[MPC Comment] Proposed Benetley Fields or Bentley Estates

[MPC Comment] Bentley Estates; No. 5-SE-16-C; August 11, 2016

Re: Bentley Estates; File No. 5-SE-16-C; Agenda Item #8; 08-11-2016

ABSTRACT OF A GROUND PENETRATING RADAR SURVEY OF A LIMITED AREA NORTH OF THE MARS HILL CEMETERY

Figure 2. GPR planview at ~20cm below surface. Note: cemetery fence is ~2m south of 3 x 3 m grid extension.

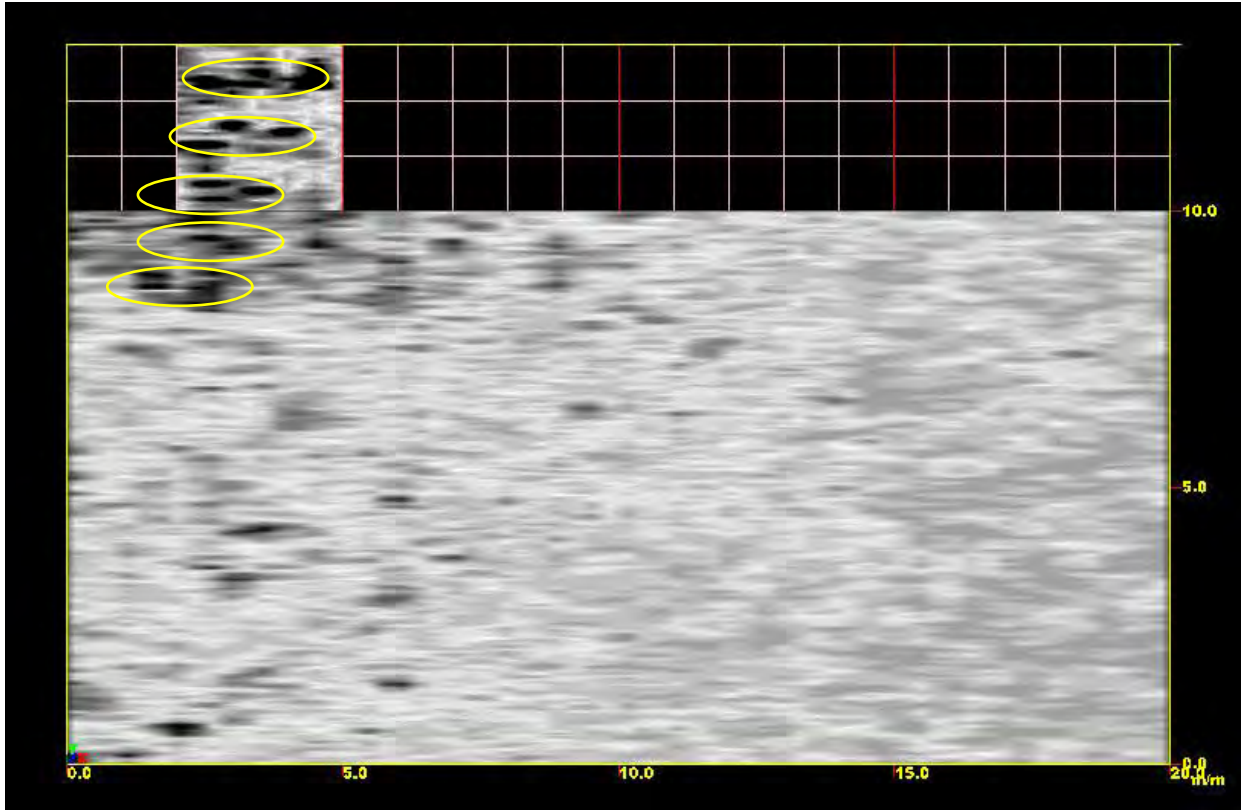
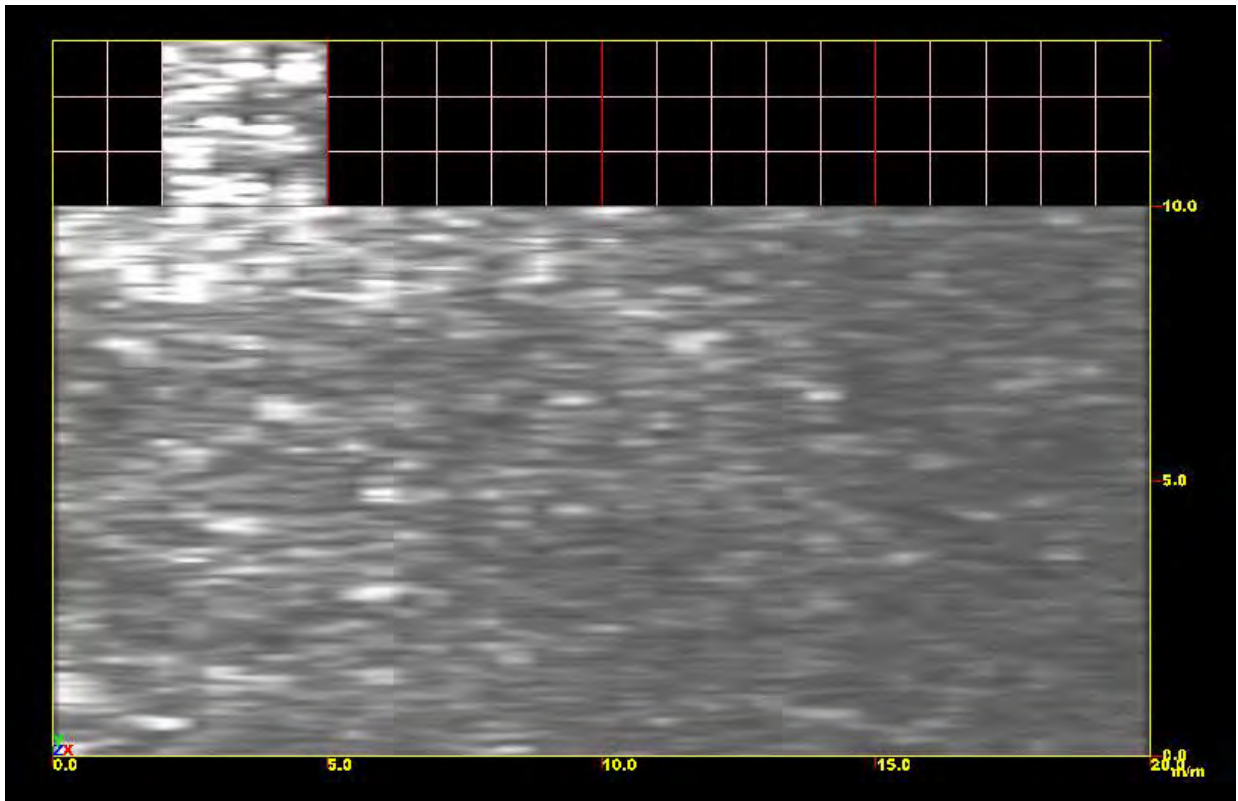
Figures 2 and 3, which are oriented with north to the bottom, show those anomalies extending almost 23 feet beyond the northern boundary of the cemetery. The top of the gridlines on Figures 2 and 3 is approximately 2 meters north of the northern line of fence posts. The anomaly most distant from the northern cemetery boundary in the limited area surveyed is approximately 7 meters from that boundary—essentially more

than 20 feet beyond the northern boundary of the cemetery, and out into the field. Others may exist a greater distance beyond the northern boundary in locations not surveyed. Based on a review of the proposed subdivision plan, this could be in the area of the access road or within the area of one or more lots.
